STATE OF NORTH CAROLINA  
DEPARTMENT OF TRANSPORTATION

Subject: **Supplemental Information to Application for Nationwide Permit 23 and 33 and Riparian Buffer Certification** for the replacement of Bridge No. 108 over Lower Barton's Creek on SR 1834, Wake County. Federal Aid Project No. BRZ-1834(2), State Project No. 8.2407901, T.I.P. No. B-3704: Division 5

NCDOT submitted a Nationwide Permit 23 and 33 and Riparian Buffer Certification application dated May 20, 2004. Since the submittal of this application it was determined by NCDOT that the design of the temporary causeway in the May 20, 2004 application would not work. Changes have been made to the temporary causeway design. Revised permit drawings and revised PCN form are included in this supplemental application. No changes have been made to any other part of this project other than the temporary causeway.

# BUFFER IMPACTS

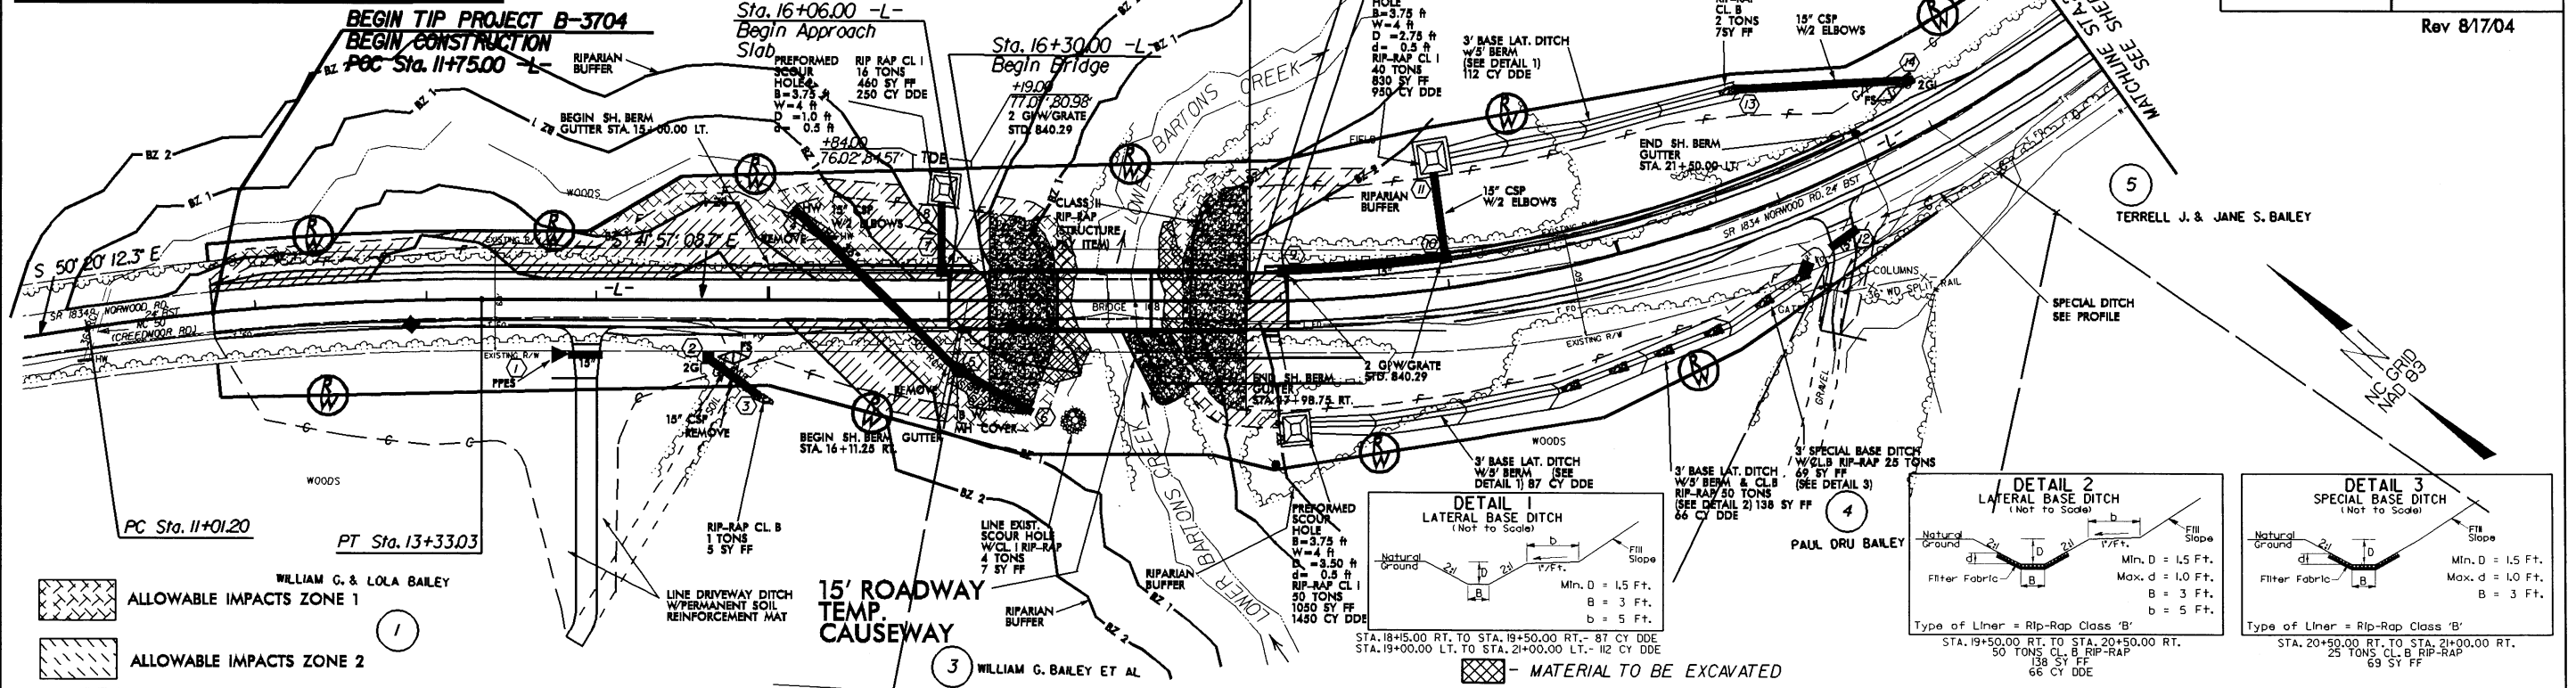
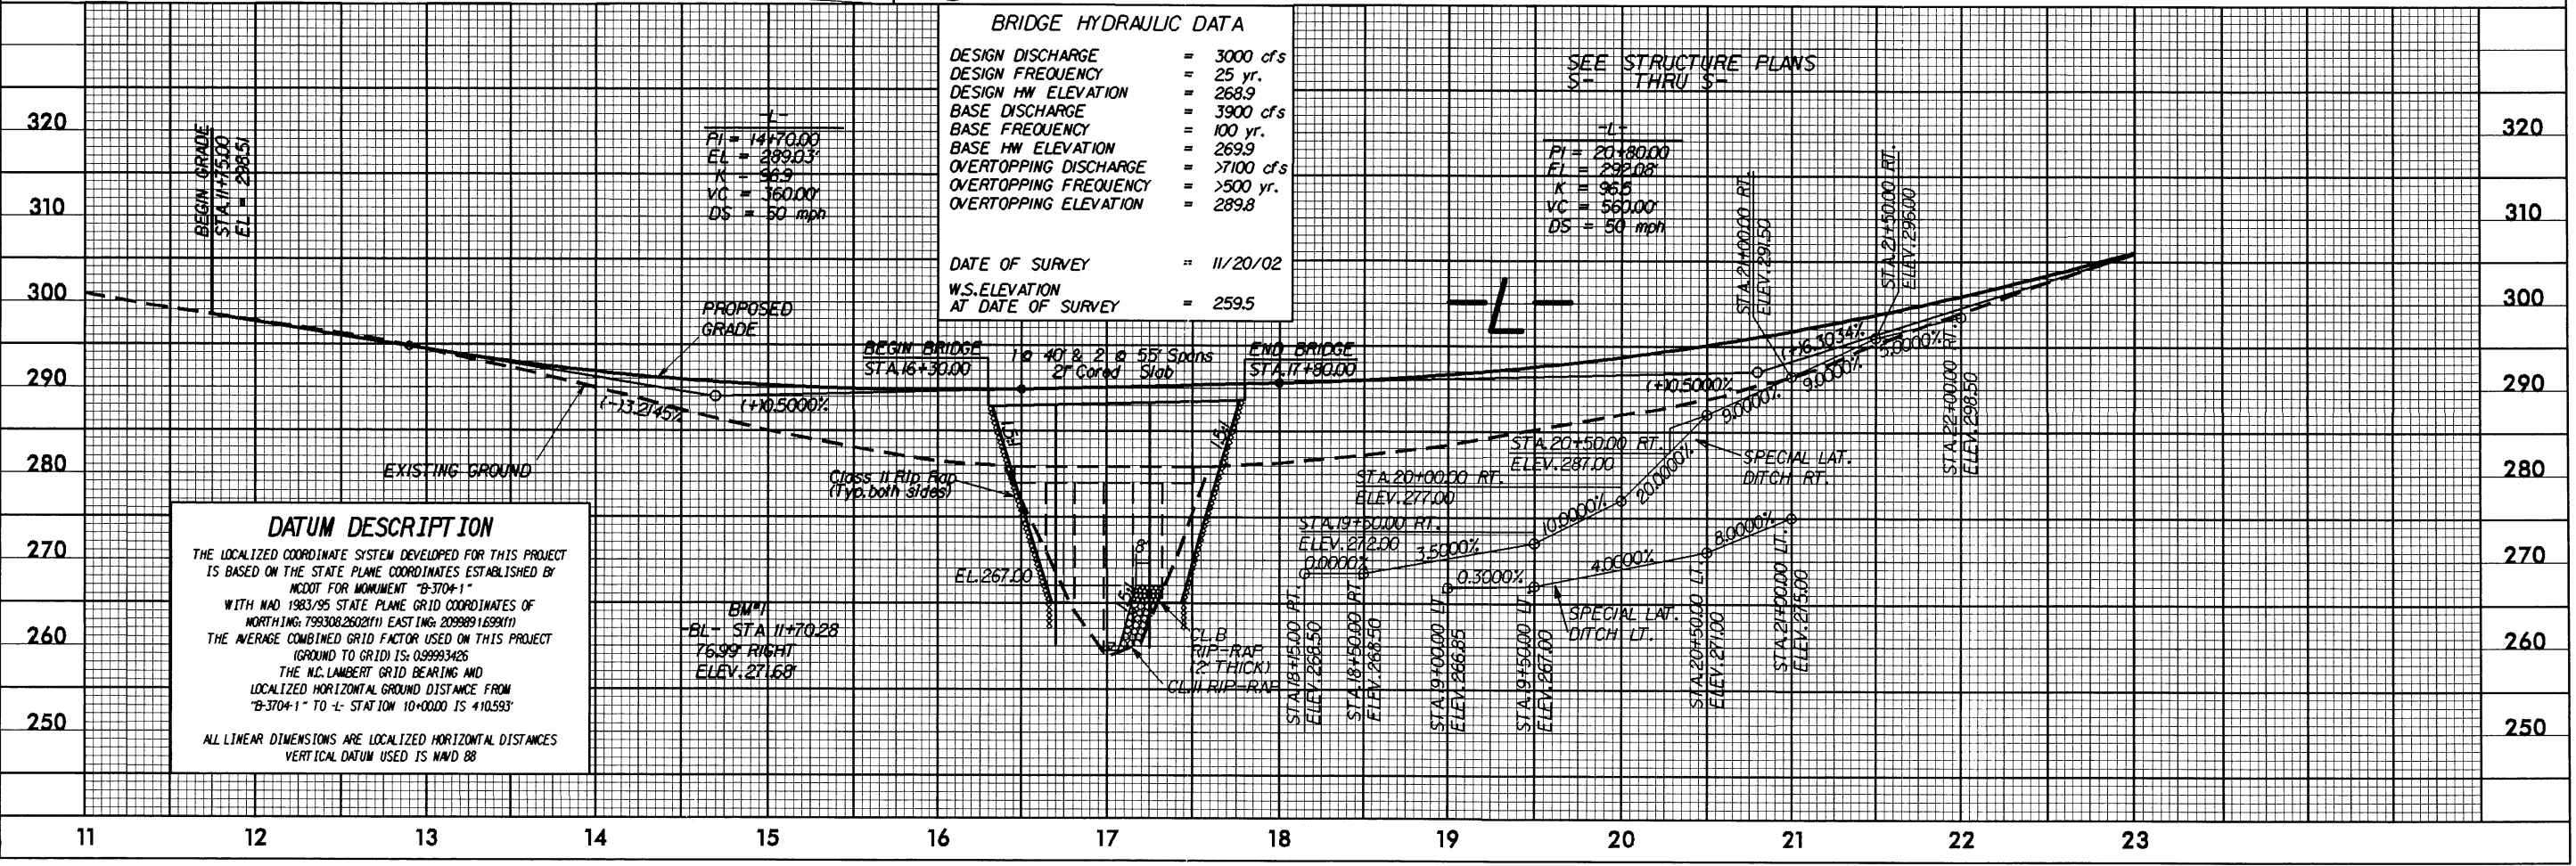
Neuse Buffer Impacts. Impacts to buffers include that of construction of the new bridge, including the temporary causeway (See permit drawing 5 and 6) and the installation of a reinforced concrete pipe. Impacts to buffers are shown in Table 2 below. The only changes to impacts to buffers are from the redesigned temporary causeway which increased by 678 sq ft from the May 20, 2004 application. Under the Neuse Buffer Rules, impacts to buffers from the construction of bridge and temporary work pad are allowable and impacts are allowable with mitigation for road crossings with impacts to riparian buffers greater than one-third of an acre.
